European Network of Transmission System Operators for Electricity

NETWORK CODE ON "REQUIREMENTS FOR GENERATORS"

EVALUATION OF COMMENTS

26.06.2012

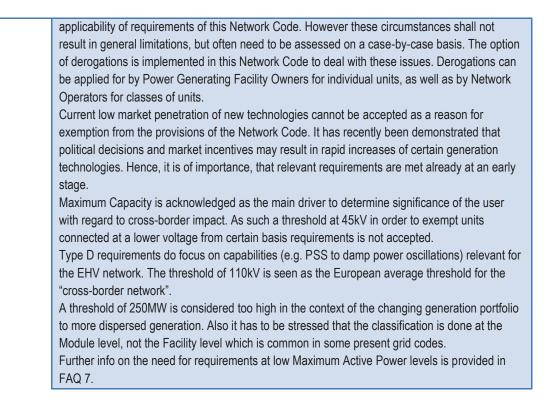
Issue	Change of the Table 1 Maximum Active Power and Voltage thresholds
Section	Article 3(6)
Proposal	From the perspective of manufacturers, the classification should be undertaken with no allocation to voltage levels. Besides, it is proposed to specify the range of each type giving no flexibility to the Member States for decision. E.g.: Type A: 3.68 kW – 1 MW; Type B: 1 MW – 50 MW; Type C: 50 – 75 MW; Type D: > 75 MW ; Other proposals included raising the voltage threshold of 110kV for type D to 170 kV. Some proposed to include a voltage threshold for type C requirements as well at 45kV. Some proposed to raise the Type D threshold to 250MW
Evaluation	Disagree
Justification	The significance test of users has to include voltage as prescribed by the FWGL. In addition a final decision on significance is to be taken at national level. The categorisation of Generating Units is based on assumptions of the future developments of the generation portfolio and the needs for secure system operation. A graded approach on significance by introducing different categories reflects the different levels of impact of generation units on cross-border network issues and shall be considered as significance criteria. It is accepted that various, possibly technology-specific, circumstances may limit the

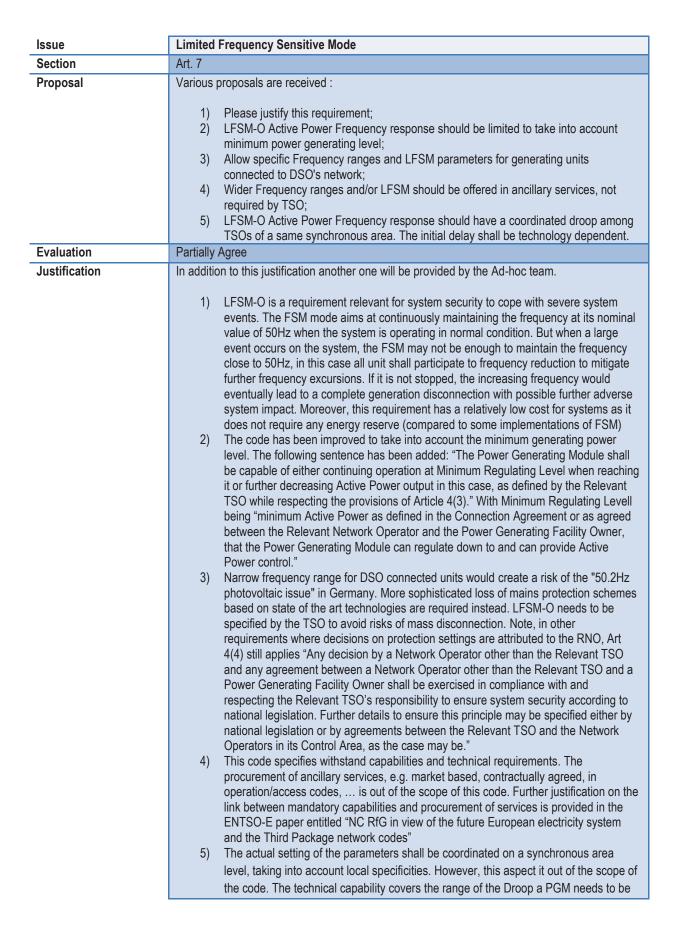
Issue	Combined requirement for voltage and frequency ranges		
Section	Art. 7		
Proposal	Add a table for combined requirements for voltage and frequency ranges in one diagram.		
Evaluation	Partially agree		
Justification	Combined interpretation of frequency and voltage ranges is elaborated in FAQ 20. As soon as one value of either voltage or frequency exceeds one of the criteria defined in this code (in magnitude of deviation and time period), units are not required to be capable to remain connected.

able to provide, the actual setting will be made by the Relevant TSO. Technology dependent initial delay of frequency response is already covered by the term "... as fast as technically feasible ...". Concerning settings of LFSM parameters, this document only describes requirement for connection, in actual operation of a network, the need is the global response.

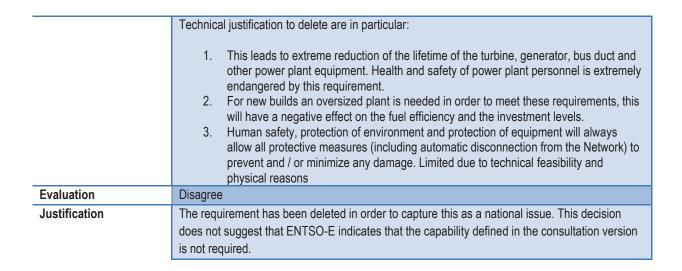
Issue	Torsional stress requirement
Section	Article 9.4.b
Proposal	 Proposals made cover the following: 1. to delete this requirements because of: Significantly deviating from present practices and as such not in line with FWGL (CBA needed), or; safety reason, or; not in line with existing standards under which shafts are design for a full synchronization fault. 2. To change the requirements: instead of routine part of normal operation, 50% steps should be consider as "exceptional cases"; 3. To remove the requirement to the chapter on Synchronous Power Generating Units because it is relevant only to synchronous generating units.

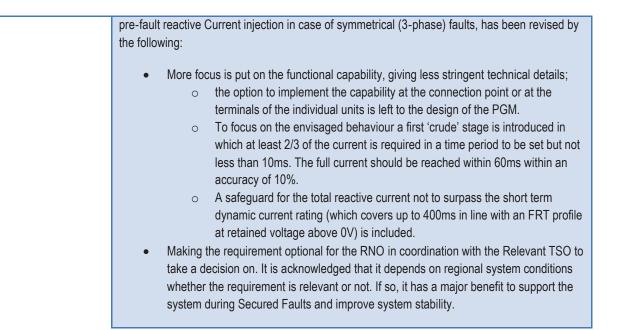
- for fast current injection it specifies implementation methods rather than required behavior. In this way the required implementation lies close to many existing patents and prevents free trade in Europe.

- The changes required are so fundamental that they cannot be achieved by some editing in the text here and there.
Evaluation	Partly agreed
Justification	Article 15(2) on fast acting additional reactive Current injection at the Connection Point to the
